AFFAIRE : TIHANGE 2 - DOEL 3

Concerne : Cure - ANNEAU SPHERIQUE
30811-002 - Réparations
Date : 8.1.76
Fournisseur : FRANACECO / Rotterdam
Nucleaire

Objet : Spherical Ring (Th.2.)

Rotterdam Nuclear		
MACHINING FOR BASE METAL REPAIR OF SPHERICAL RINGS ITEM 308II-002		
SCHAAL	2 : 1	20 mm
SCALE	1 : 1	40 mm
	1 : 2	100 mm
	1 : 5	200 mm
	1 : 10	400 mm
	1 : 25	1000 mm
DRAWN BY: HZEK		REVISED
DATE: 24-1-1975		APPROVED BY:
SHEET NO. 1 OF 1		DESIGNER:
SUB ORDER NO. 308II		DATE:
GEWICHT		WEIGHT

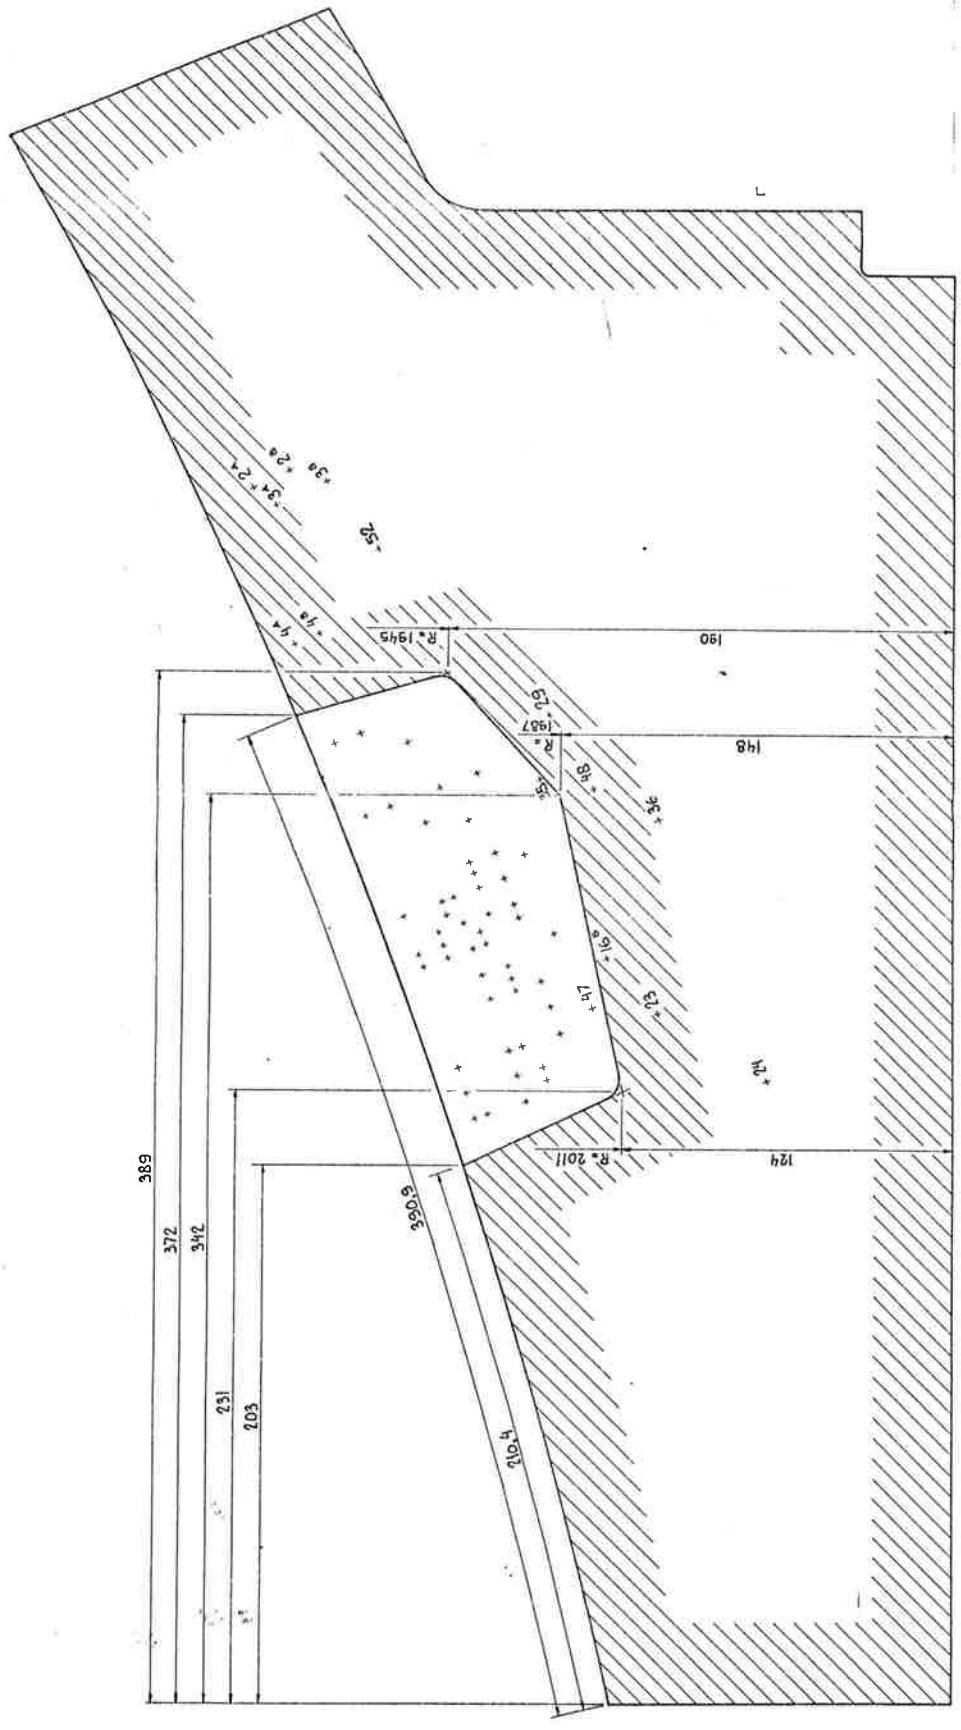
1.1 Magnaphone showed indications out of the standards.

1.2. A new indication was found in the piece by UT yesterday-

dimensions : 50 x 10 mm.

10 mm below the machining surface.

(CKL asked to RN to not remove this indication because the groove is already at $\frac{1}{3}$ T.)

Repair is unacceptable:

- suspect metal at the boundary of the weld repair.
- indications remaining (after $\frac{1}{3}$ T.)
- qualifications ^(possibly) not in accordance with ECA (with probable delay.)
- delay very probable due to the repair - (costs of contract.)

All these considerations bring to rejection of this item.

The customers and CNE and FRA ask to R&D not to scrap this piece, because in the future it's in front of a big delay problem (due to the fact that the new piece would not be good.) The customers would accept eventually a successive inspection of this repair.
